# **Architectural Review Board**

February 26, 2019
Council Auditorium, City Hall
103 North Perry Street

LAND USE DIVISION

2425 East Cloverdale Park

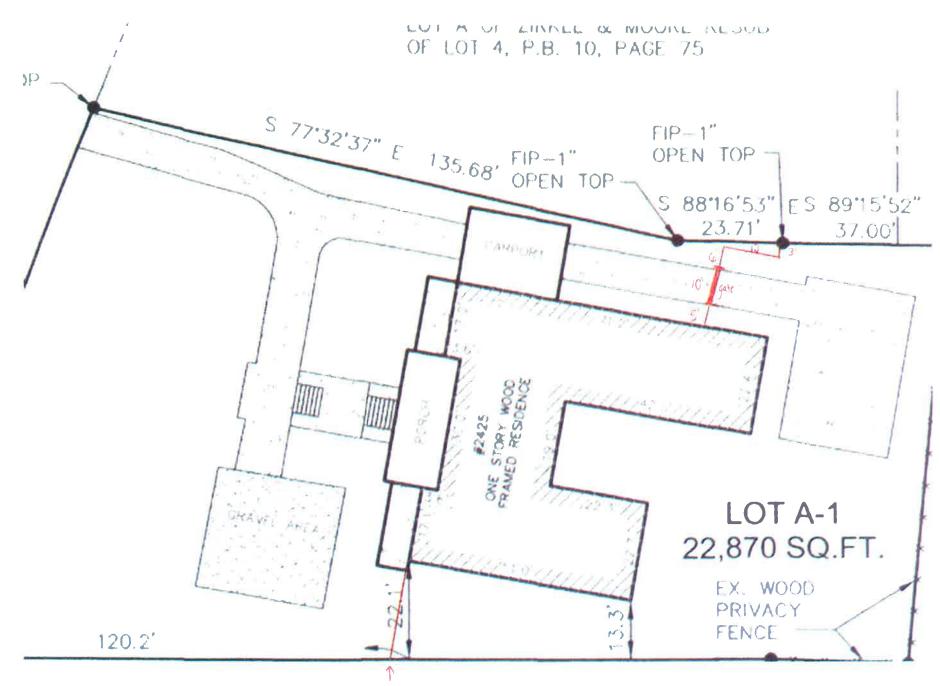
- The Board has generally approved rear yard fences when they have been recessed from the front corner of the house. The south (right) side has a fence placement at the front corner. That corner is screened from the street fairly well because of vegetation required for the front parking area from a previous project.
- Metal fences and gates have been approved, usually with simple being better

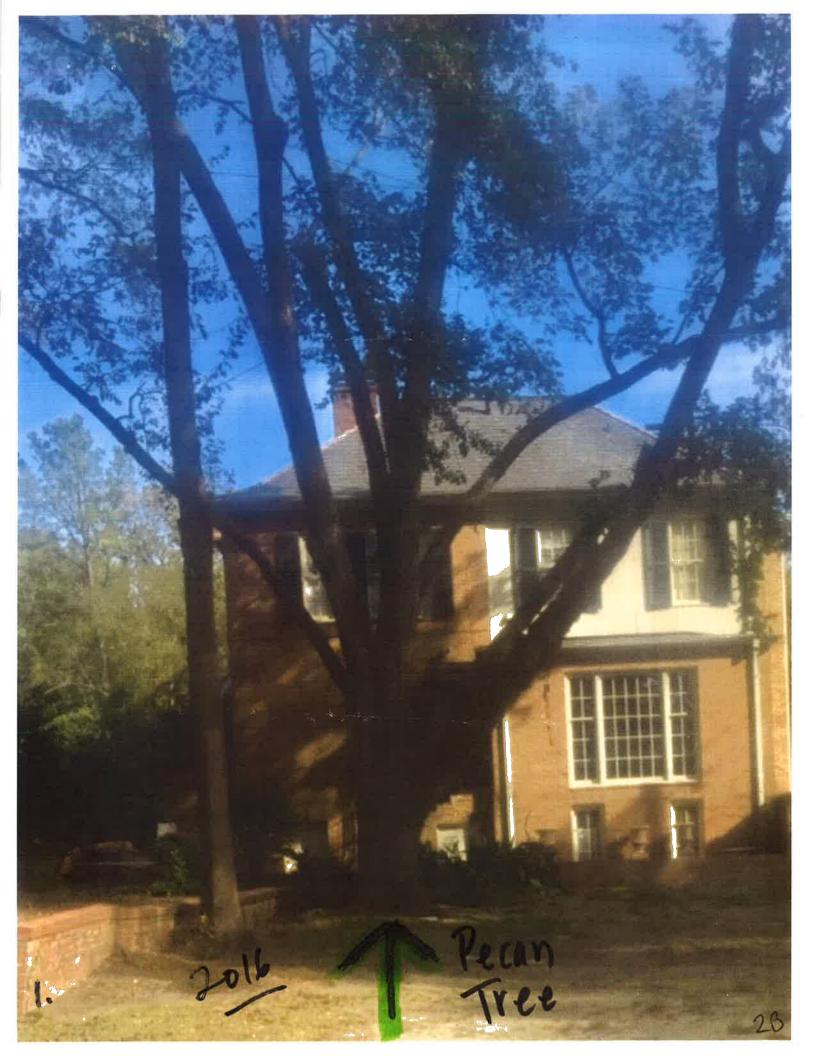
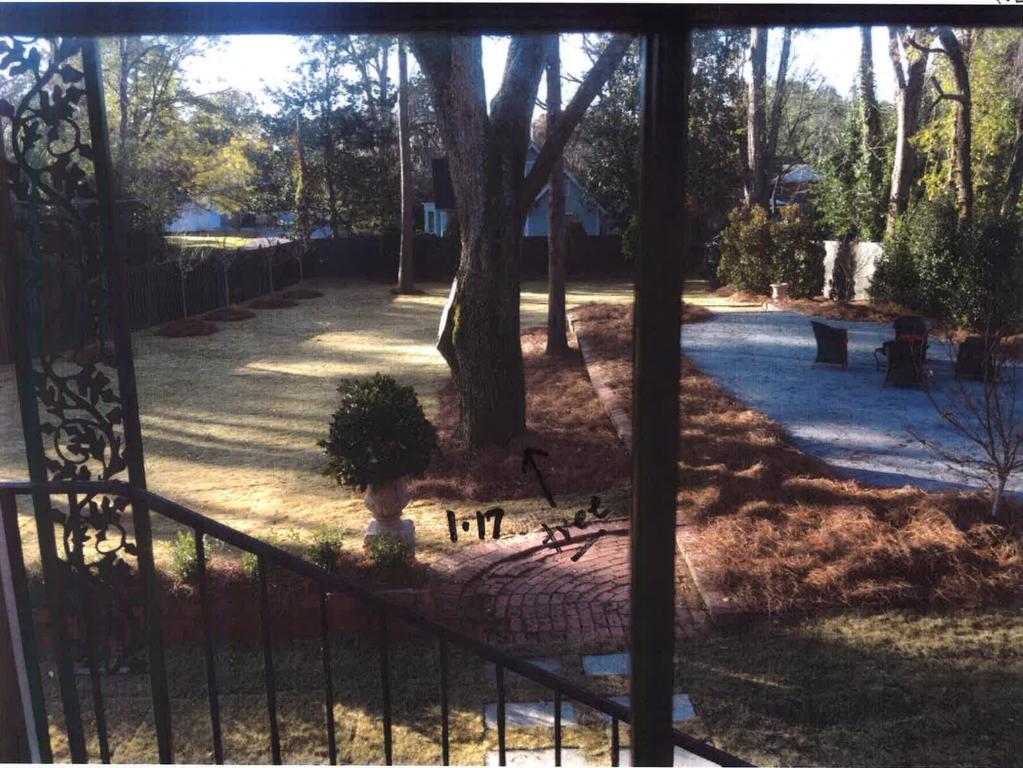
• No objection from the Urban Forester.

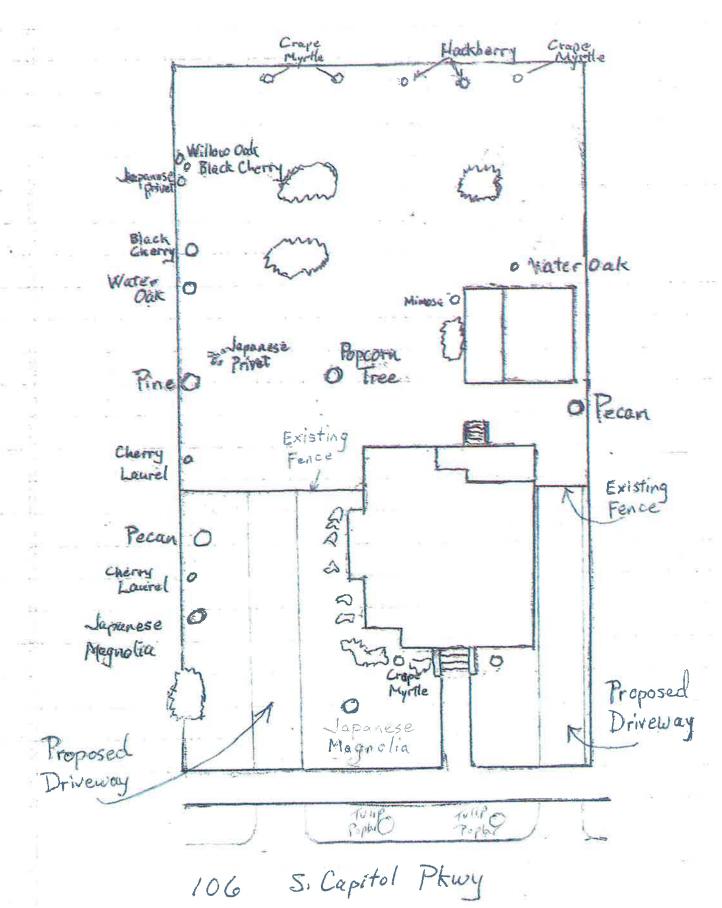
• The proposal of concrete runners is consistent with other houses on the street.

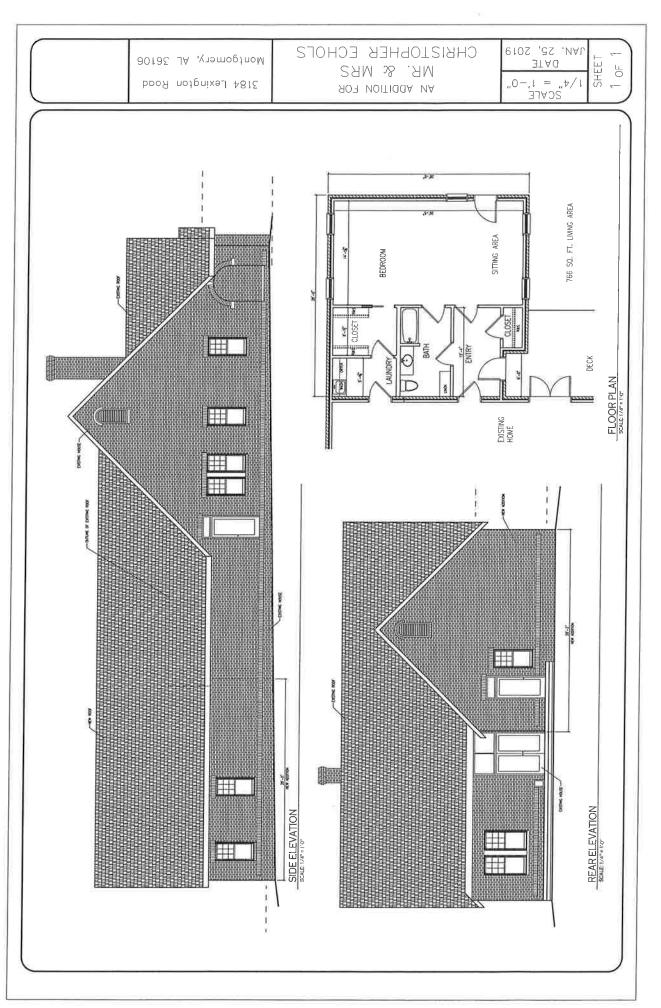
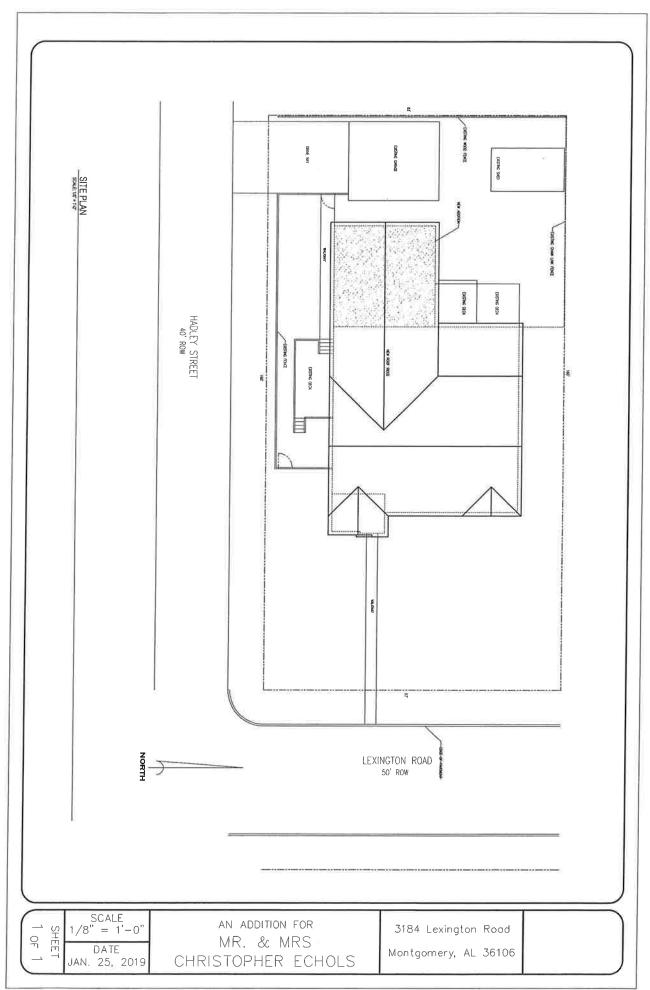
- While the Board does not generally approve windows with a grid between the glass, the windows in the house had been replaced at least 2 owners ago and would provide the most consistent appearance.
- The Board has asked that there be some delineation between the original house and additions so as to not confuse the addition as an original portion of the house, per the Secretary of the Interior's Standards.

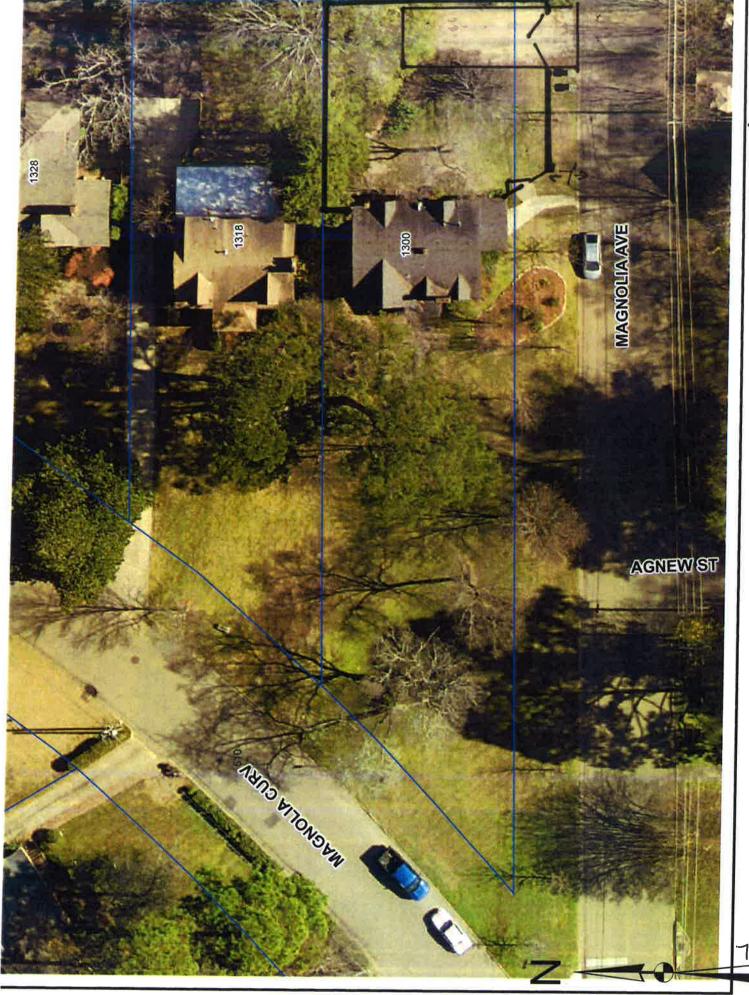
•	The Board is asked to consider the placement in the ROW and on the property line so that if City Council denies the ROW request, the petitioner would only have to visit the Board of Adjustment and not revisit us.
